**Re: Natural Gas Combined Cycle Minor Modification
Electric Transmission Line and Storm Outfalls Rehabilitation
NPDES Permit #: PAC060046
BCCD Project ID #: ESP-00731
Dawood Project No. 216040.01**

Enclosed, please find revised documents for the above-referenced project updated to accommodate the installation of poles required to connect the substation to the existing overhead line north of the substation site off Boonetown Road. These documents have been revised to adjust the limit of disturbance, show E&S control for the additional area, and demonstrate that the 2-year volume increase associated with the two pole foundations does not exceed the predevelopment volume for the site.

TITLE:	PRE-CONSTRUCTION MAP
WELL(FARM) NAME:	BIRDSBORO SUBSTATION
LOCATION:	EXETER AND ROBESON TOWNSHIPS & BIRDSBORO BOROUGH, BERKS COUNTY, PENNSYLVANIA
MAP REFERENCE:	USGS QUADRANGLES: BIRDSBORO, PA
PROJECT NUMBER:	216040.01
DRAWN BY:	TS
APPROVED BY:	JP

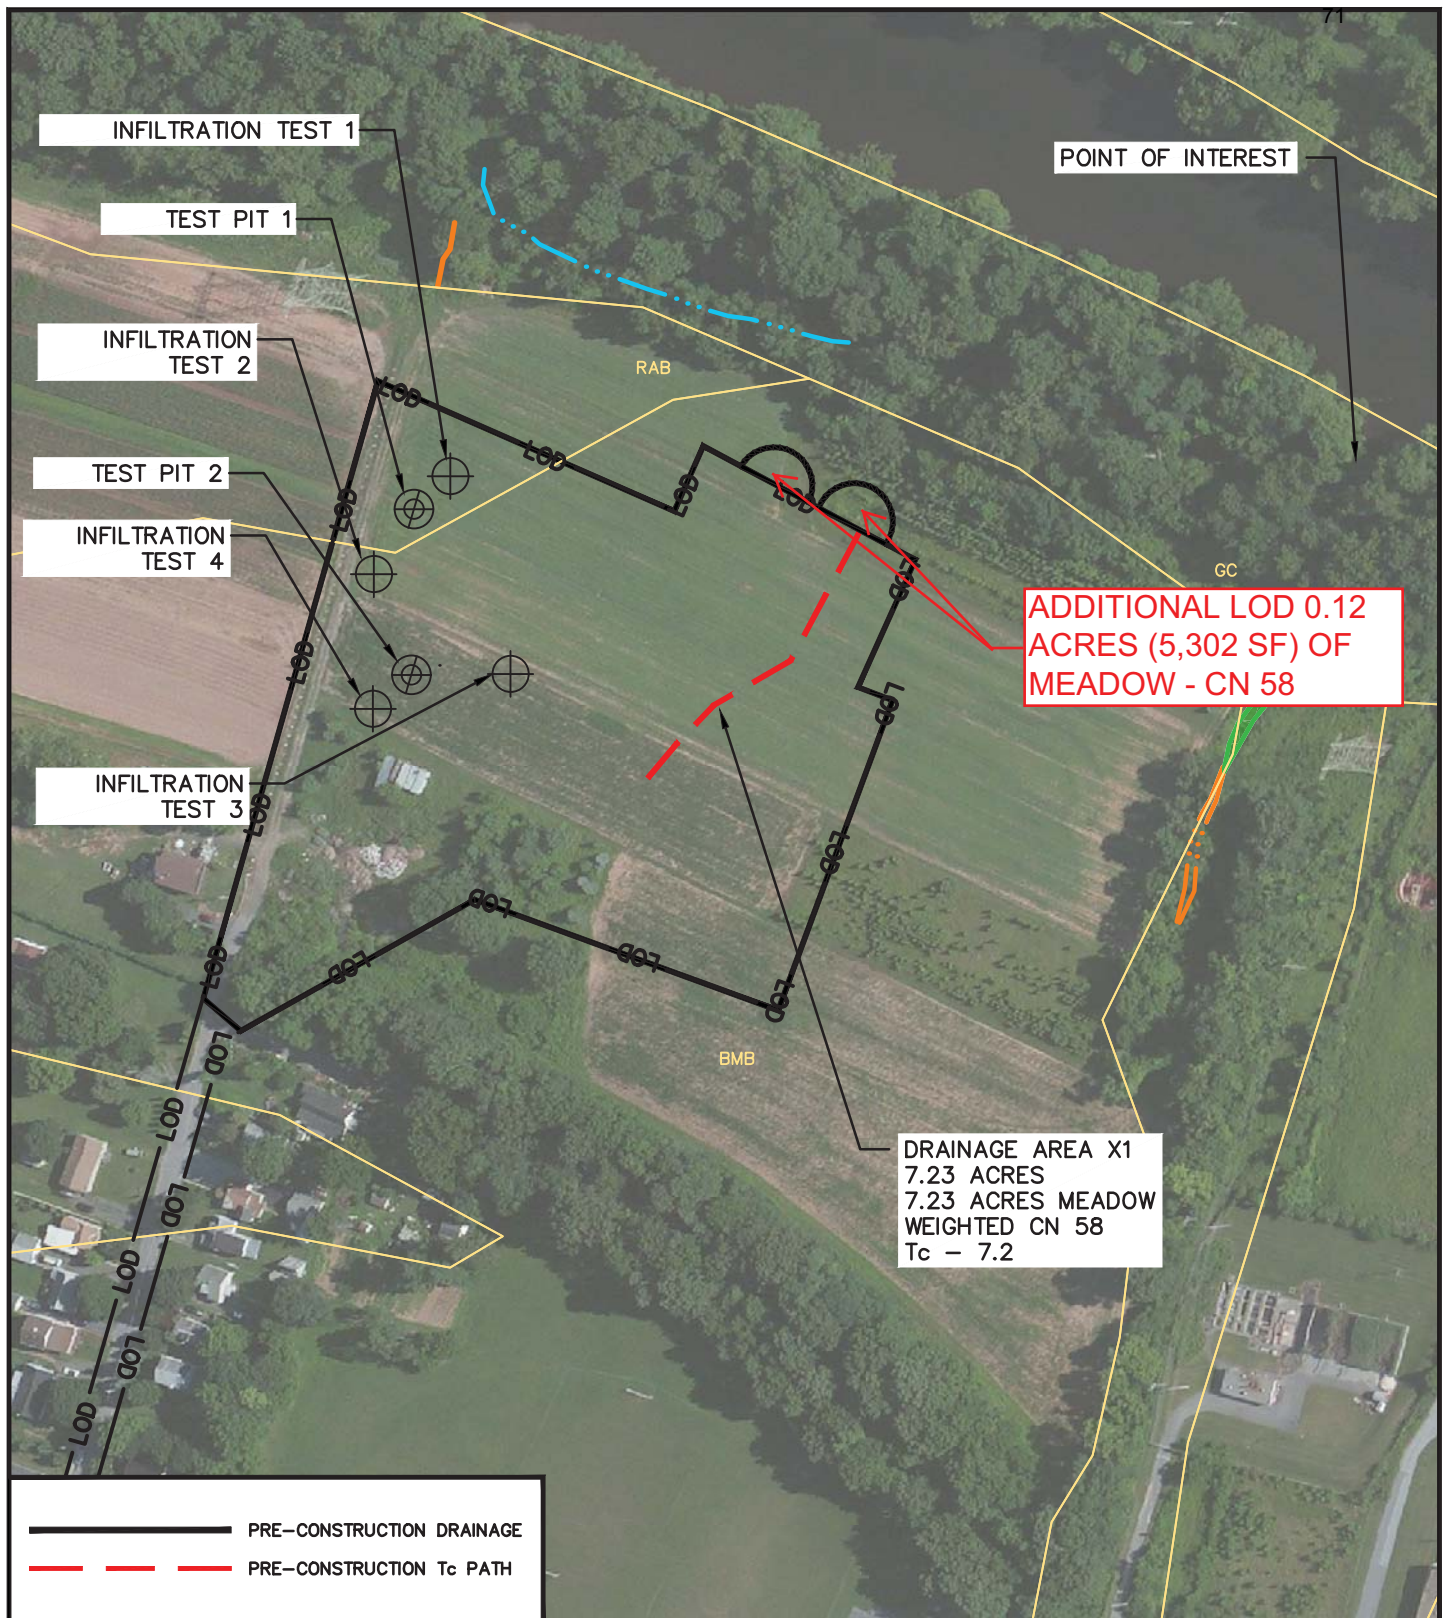
2. Substation Pre-Construction Map (Page 71) – Total Disturbed area has been increased by 5,302 SF to allow installation of connection poles.
3. Substation Post-Construction Map (Page 72) – Total Disturbed area has been increased by 5,302 SF to allow installation of connection poles.

DATE	JANUARY 12, 2017
JOB NO.	216040.01
FILE NAME	LDP-FL-ES01
SCALE	AS SHOWN
DRAWN BY	TRS
CHECKED BY	JTP
SHEET NO	B102

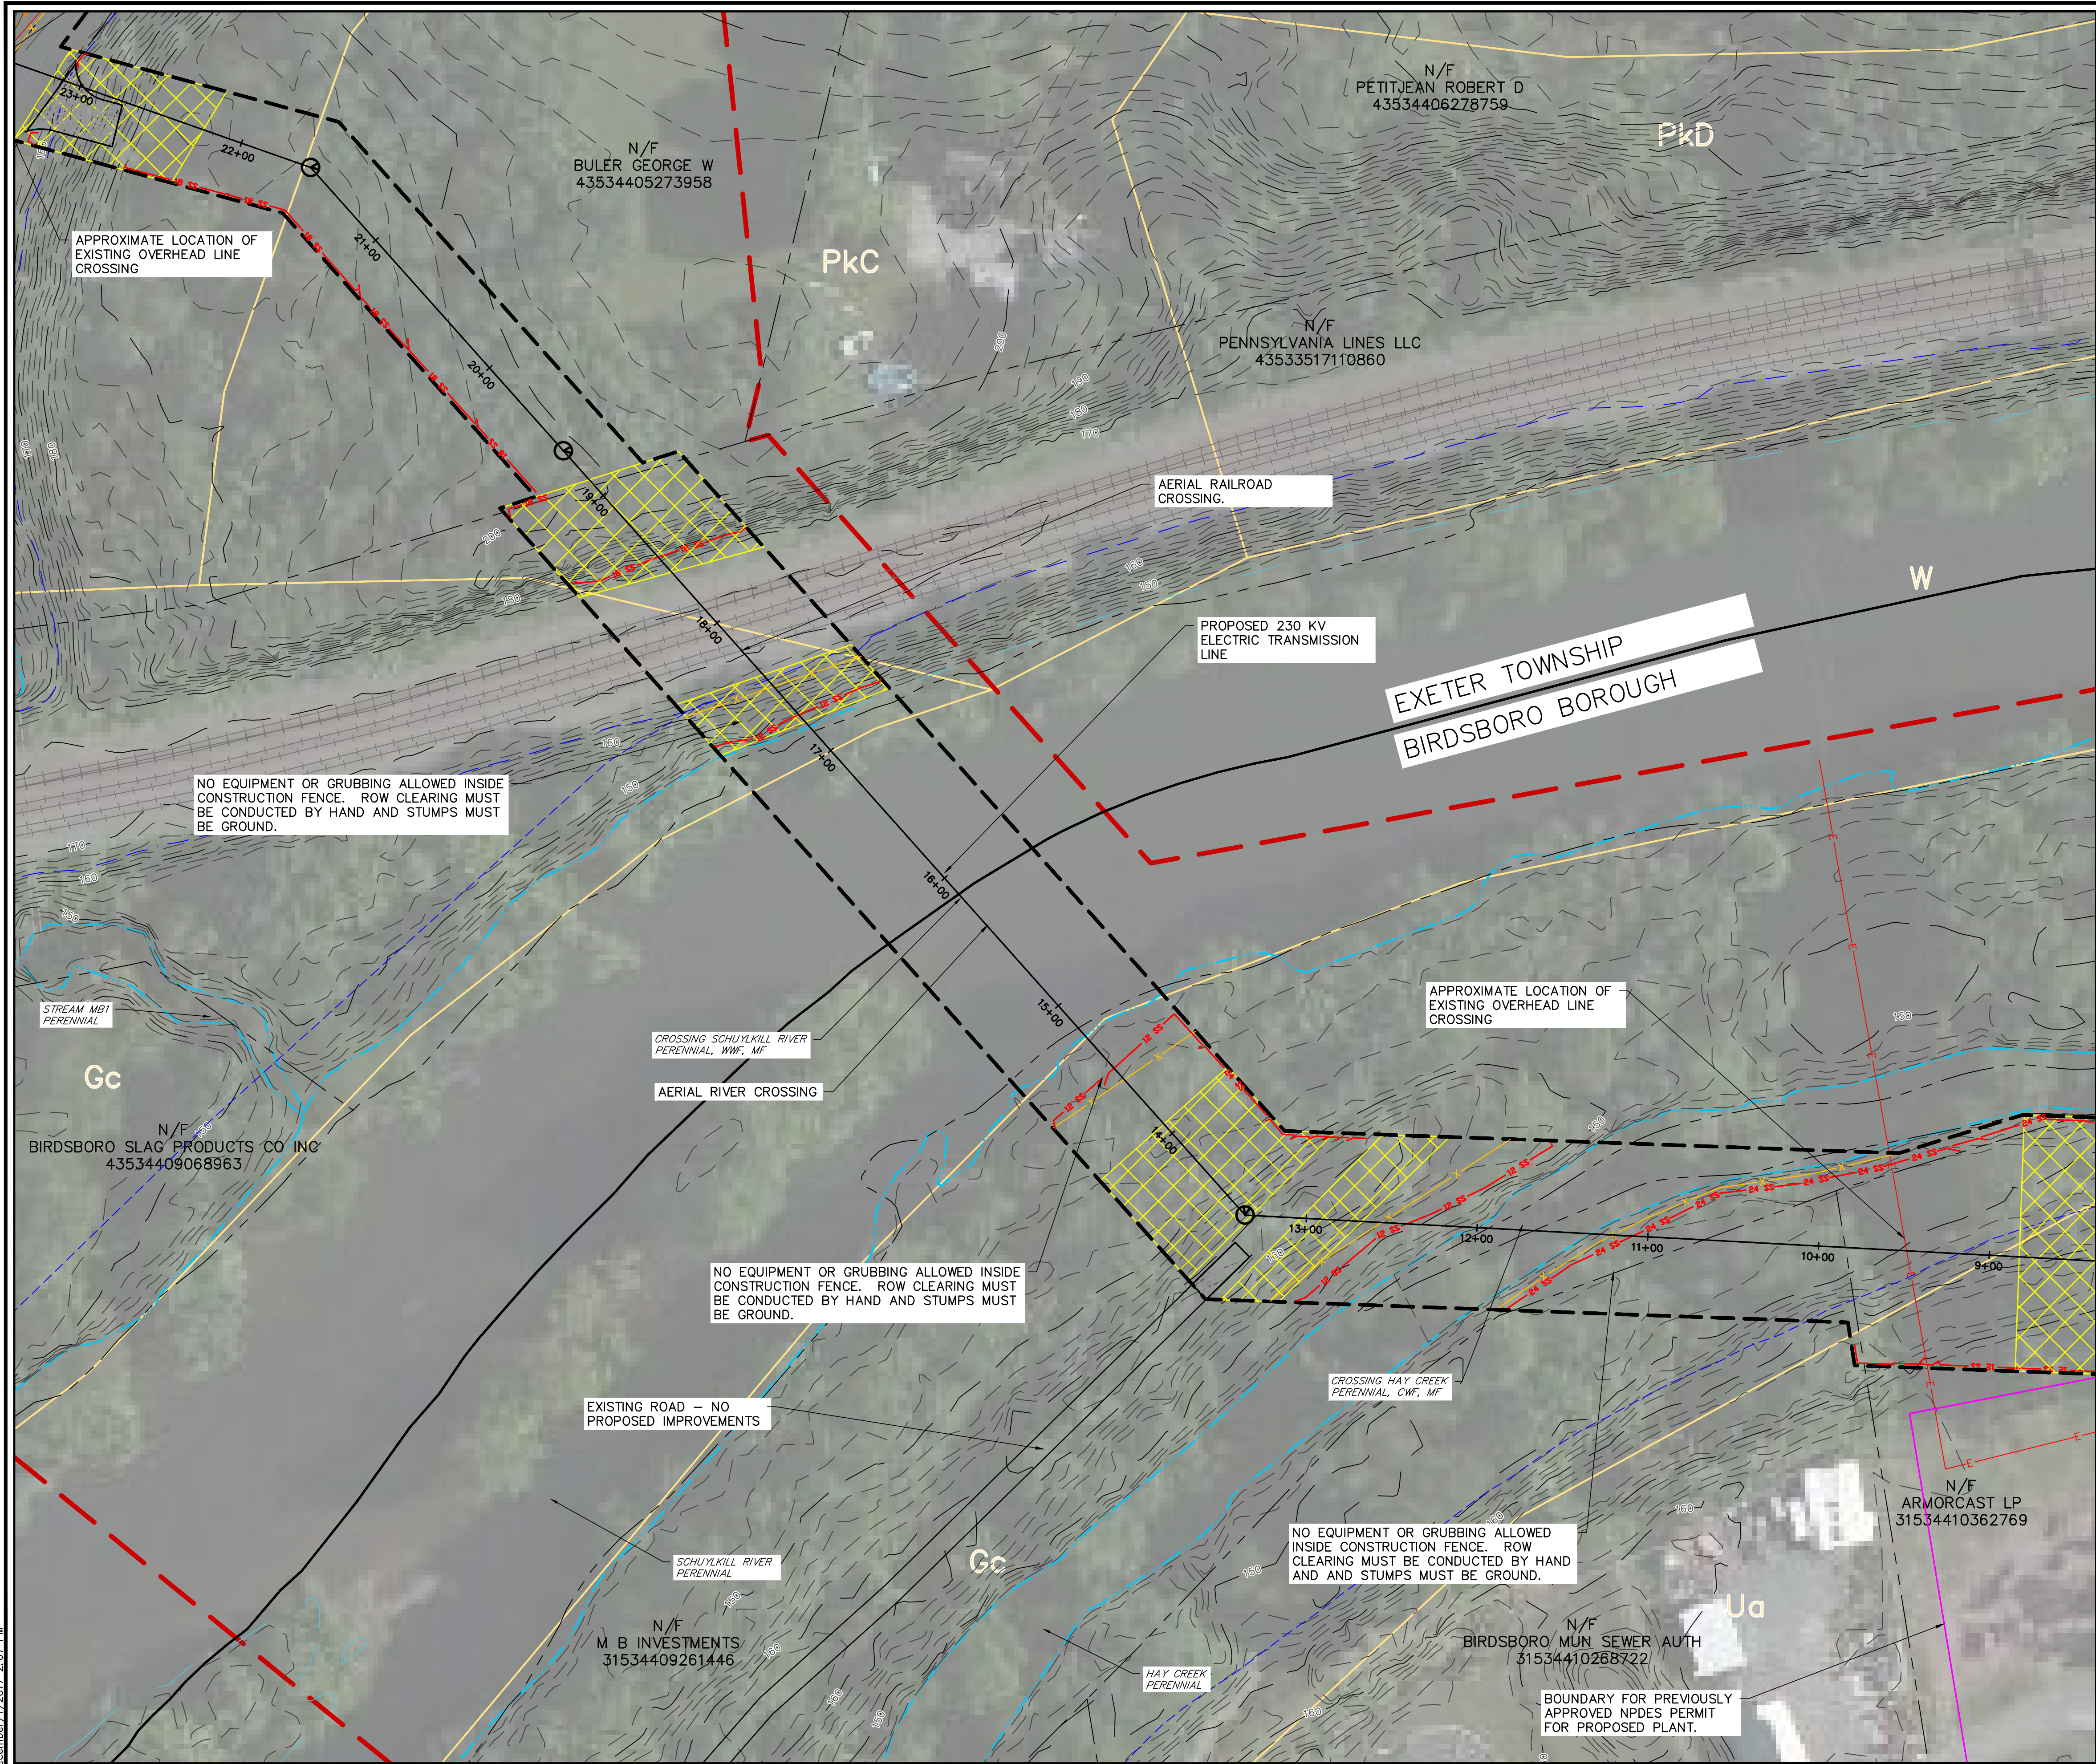
5. Substation point of interest NPDES WS 5 (Page 110) – Demonstration that Post-development 2-year volume is reduced from Pre-development condition.
6. ESCP B102 (Page 401)– Total Disturbed area has been decreased to from a 150' wide limit of disturbance to a 100' wide limit of disturbance on the Pennsylvania Lines, LLC Parcel (43533517110860) based on comments received from Chapter 105 review.

B103

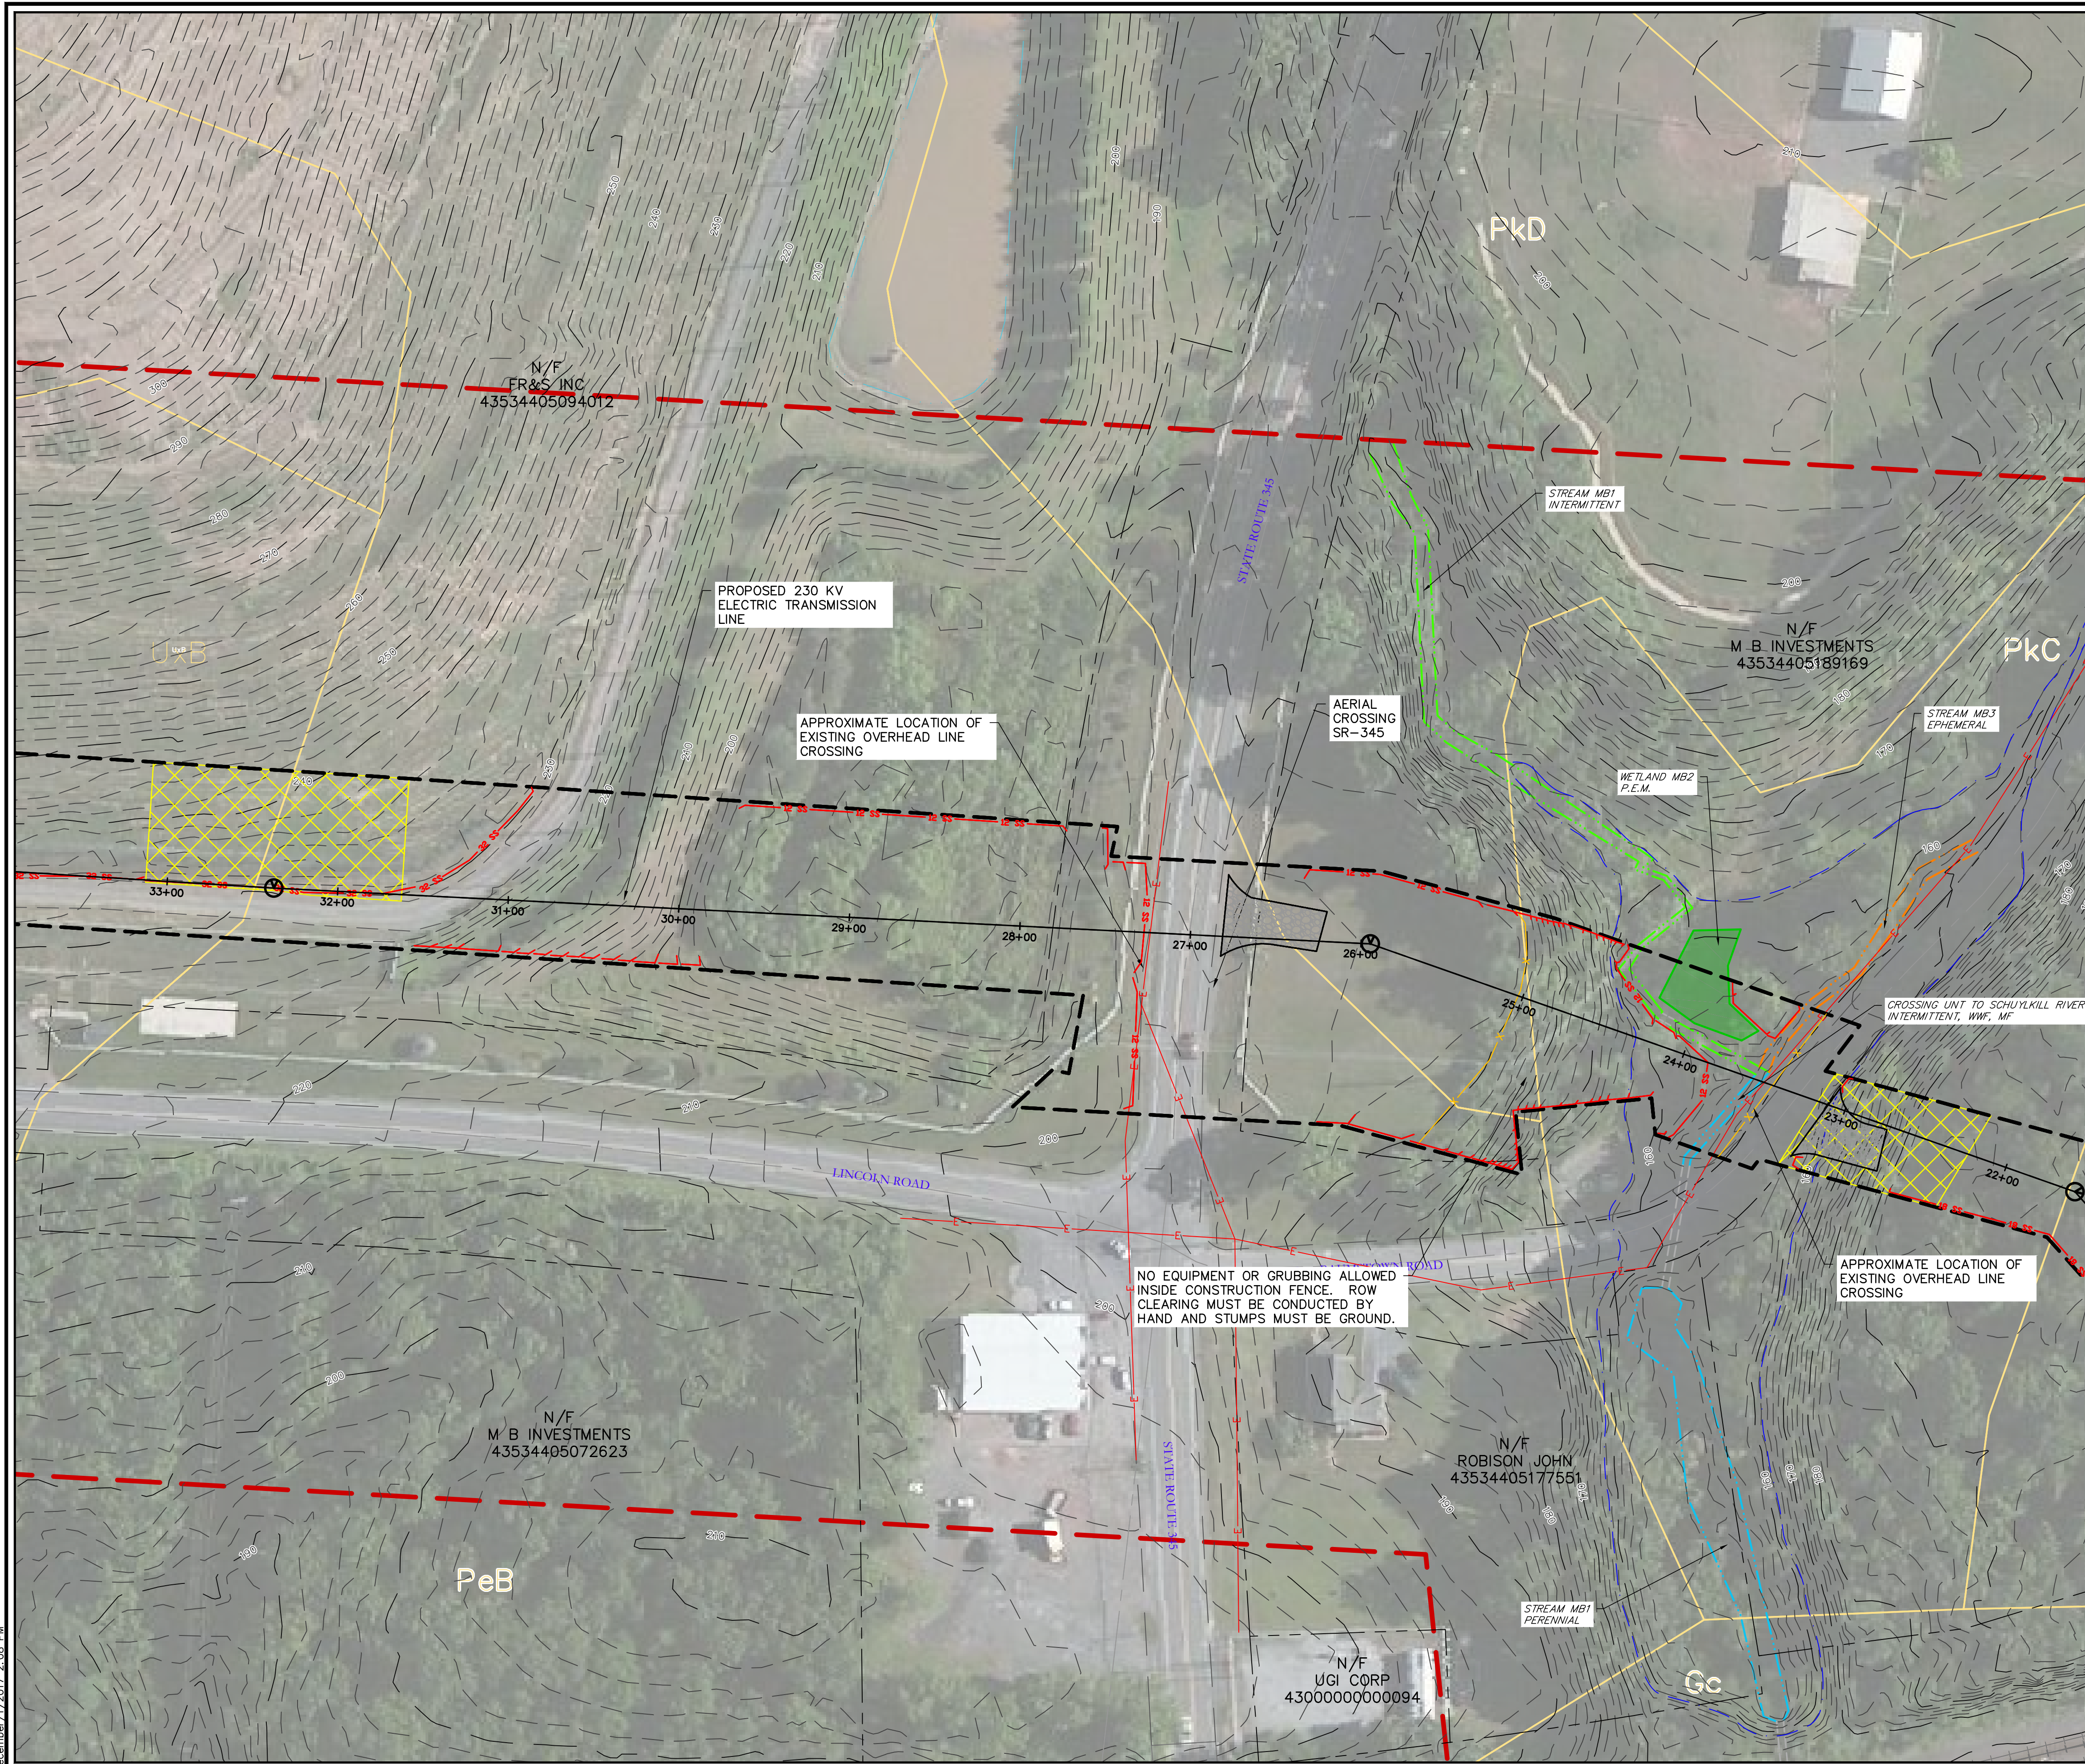
7. ESCP B103 (Page 402)– Total Disturbed area has been decreased to from a 150' wide maximum limit of disturbance to a 100' wide maximum limit of disturbance from station 23+00 to 24+50 based on comments received from Chapter 105 review.
8. ESCP B106 (Page 405)– Total Disturbed area has been decreased to from a 115' wide limit of disturbance to a 90' wide limit of disturbance from station 61+00 to 65+00 based on comments received from Chapter 105 review.
